49 CFR Part 572

Anthropomorphic Test Devices; Hybrid III Test Dummy, ES-2re Side Impact Crash Test Dummy

ACTION: Notice of proposed rulemaking (NPRM).

FIGURE 22
PENDULUM SPECIFICATIONS

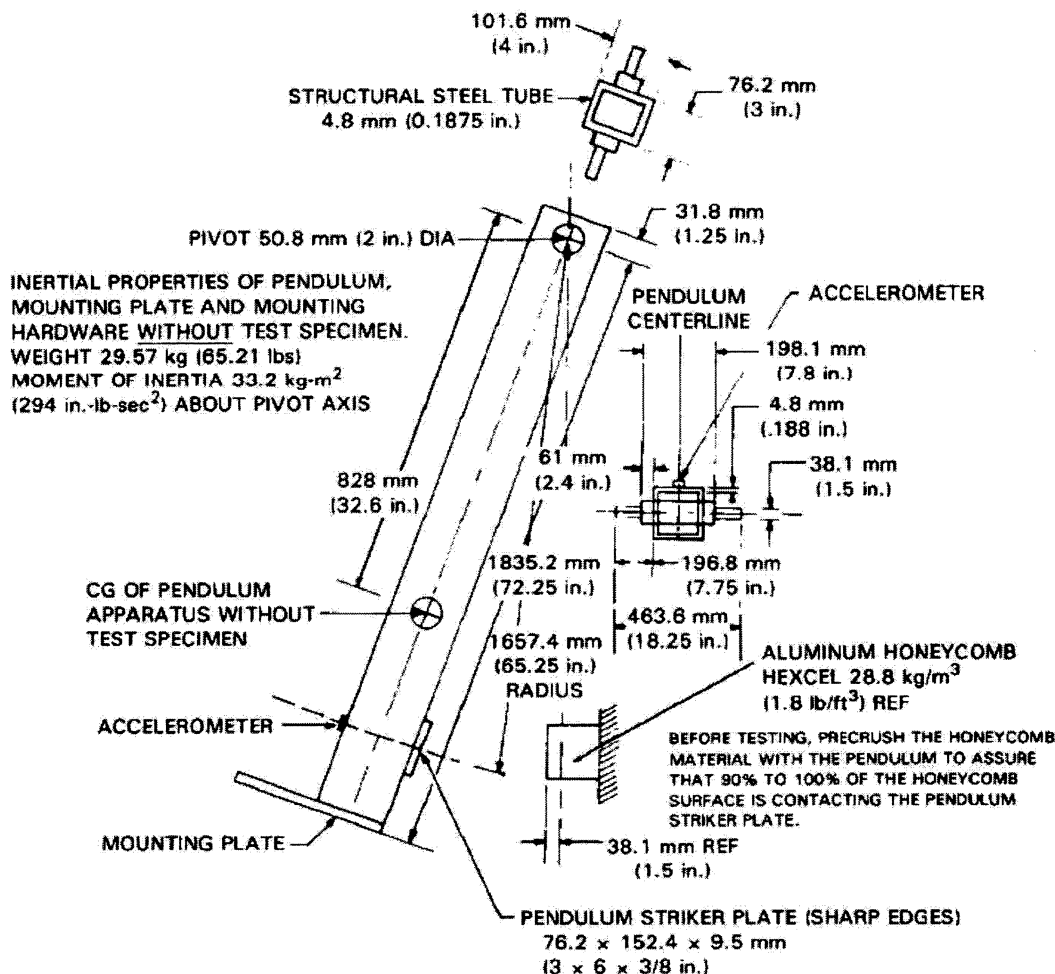
IV. Corrections to Figure 22

NHTSA observed that Figure 22, “Pendulum Specifications,” of 49 CFR part 572 has several dimensional errors that need correction. This pendulum is used in neck qualification tests for the ES–2re as well as other adult crash test dummies, including the Hybrid III 50th percentile male and 5th percentile female frontal crash test dummies, the SID–IIIsD 5th percentile female side impact dummy, and the SID and SID/HIII side impact crash test dummies. The dimensional corrections that should be made to this figure are listed below and shown in Figure 1 of this preamble, below:

- The 8.28 millimeter (mm) (32.6 inch (in)) dimension should be 828 mm (32.6 in);
- The 4.8 mm (188 in) dimension should be 4.8 mm (0.188 in);
- The 198.6 mm (7.75 in) dimension should be 196.8 mm (7.75 in).

2. In § 572.33, revise Figure 22 following paragraph (c)(3) to read as follows:
